URBAN COLLECTION AT PALMER VILLAGE

EL PASO COUNTY, COLORADO CONSTRUCTION DOCUMENTS

EPC STORMWATER REVIEW COMMENTS
IN ORANGE BOXES WITH BLACK TEXT

PCD-ENGINEERING REVIEW COMMENTS
IN BLUE BOXES WITH BLUE TEXT

SHEET 1 OF 29

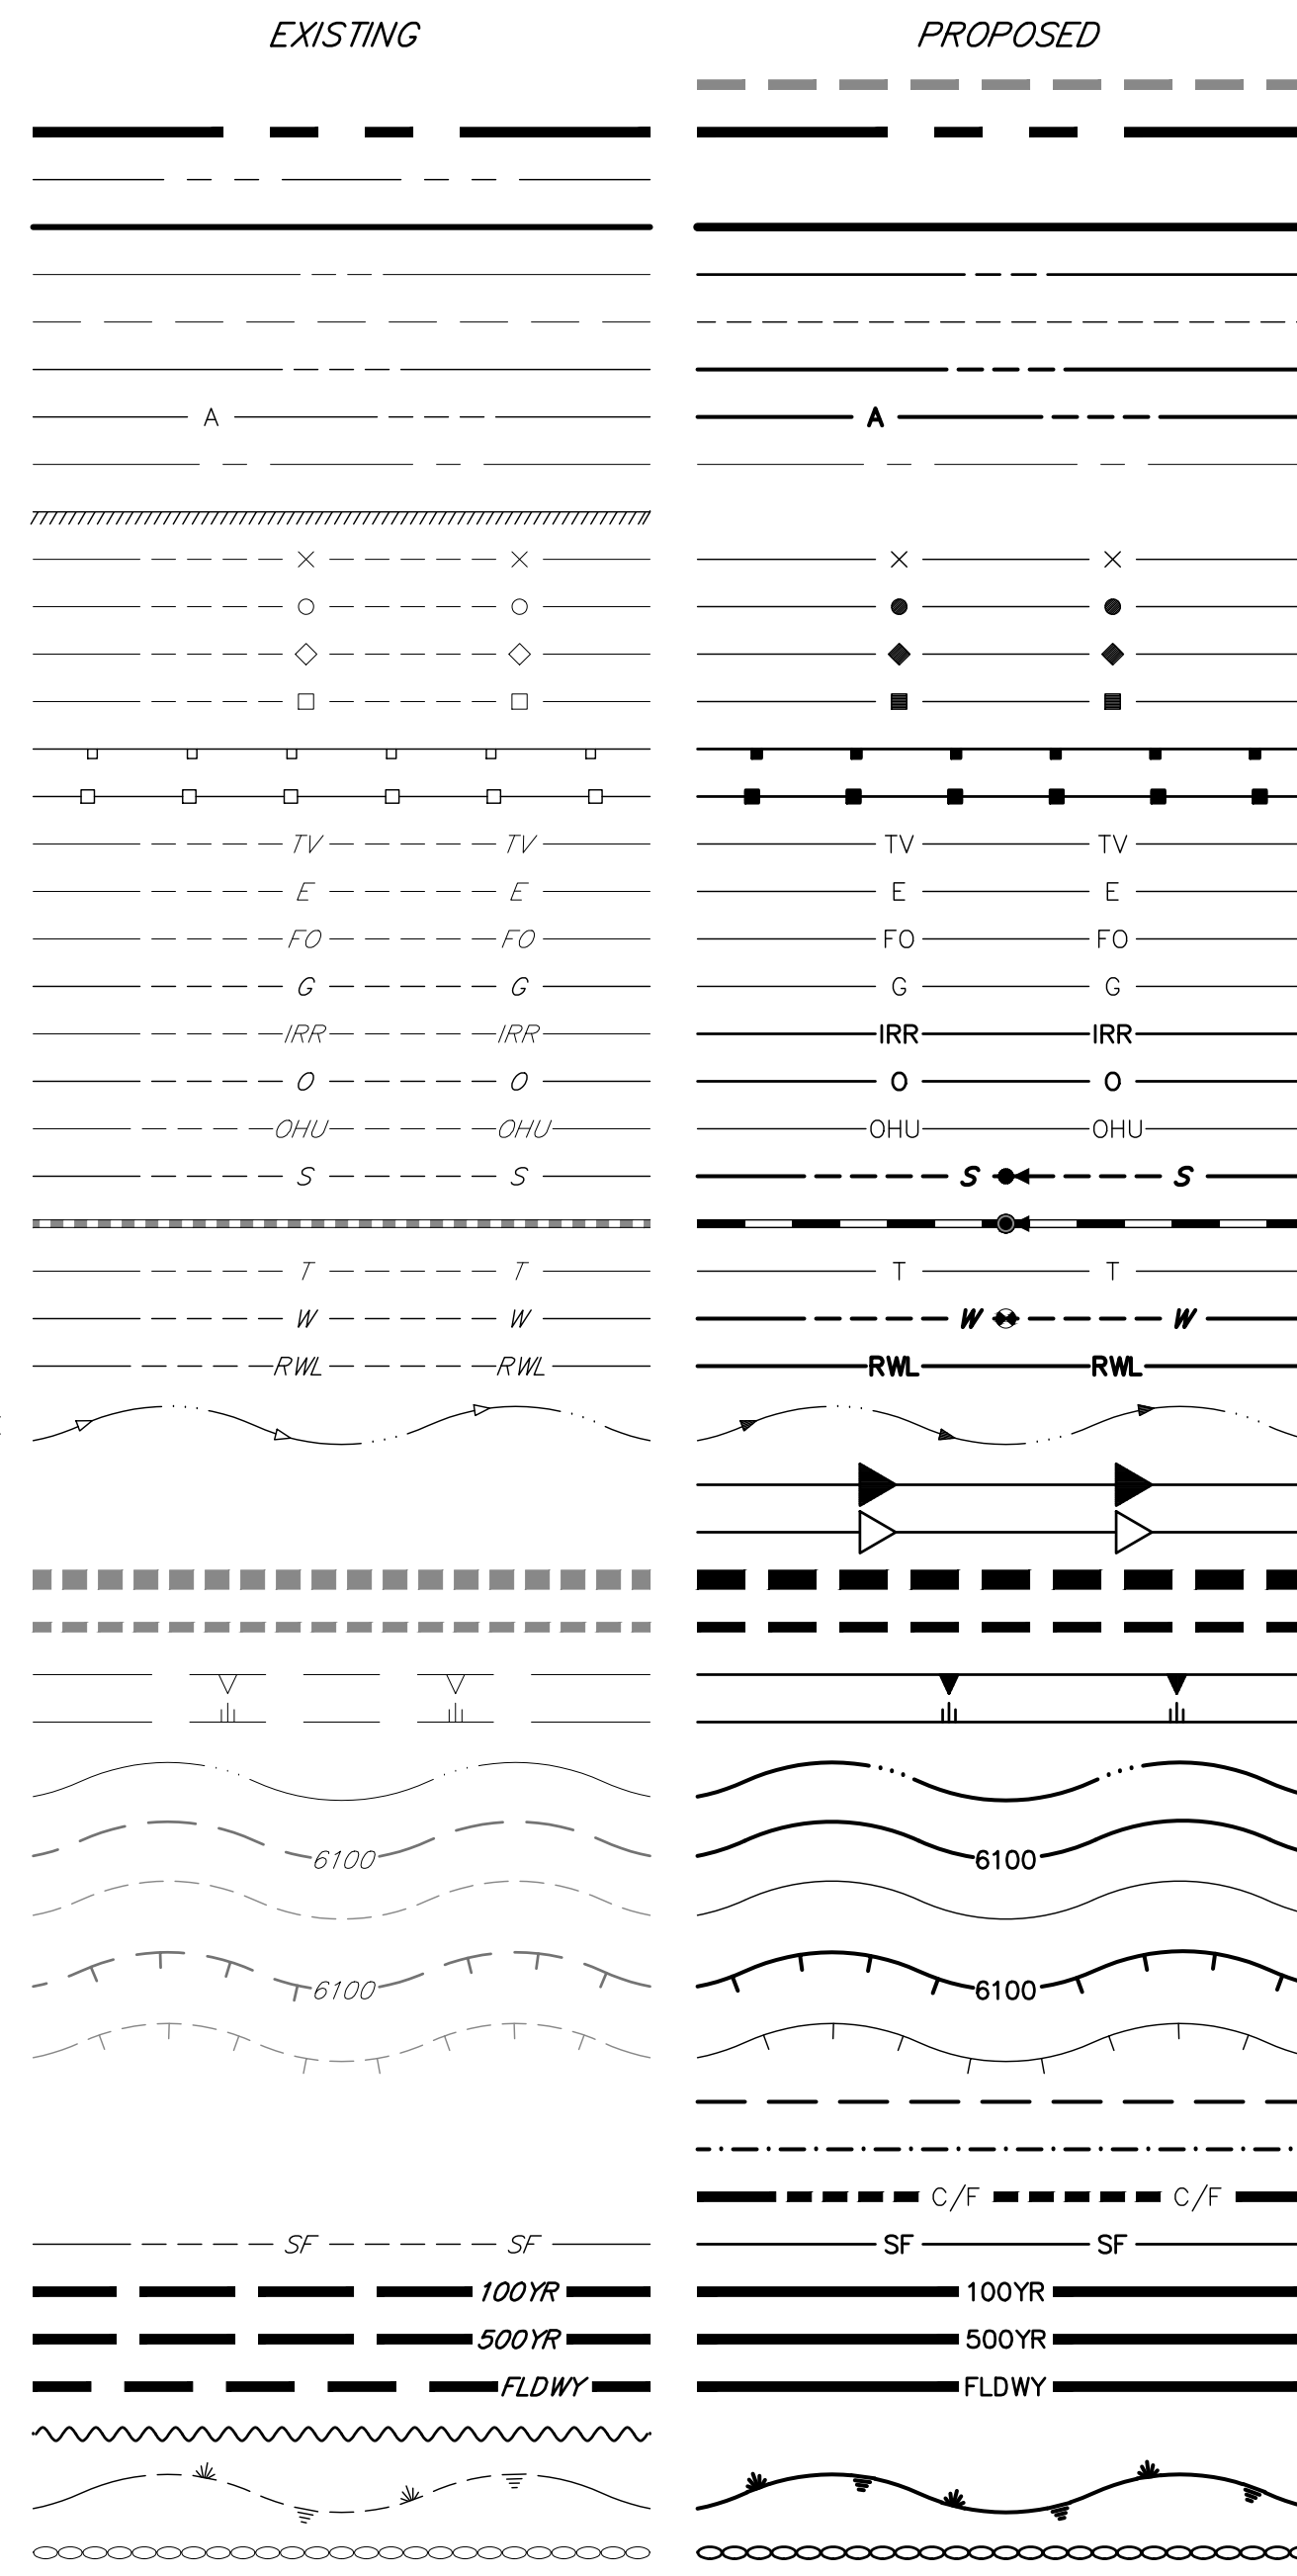
Clarify per updated plat statement.

Change to:
El Paso County PCD
(719) 520-6300

El Paso County DPW
(719) 520-6460
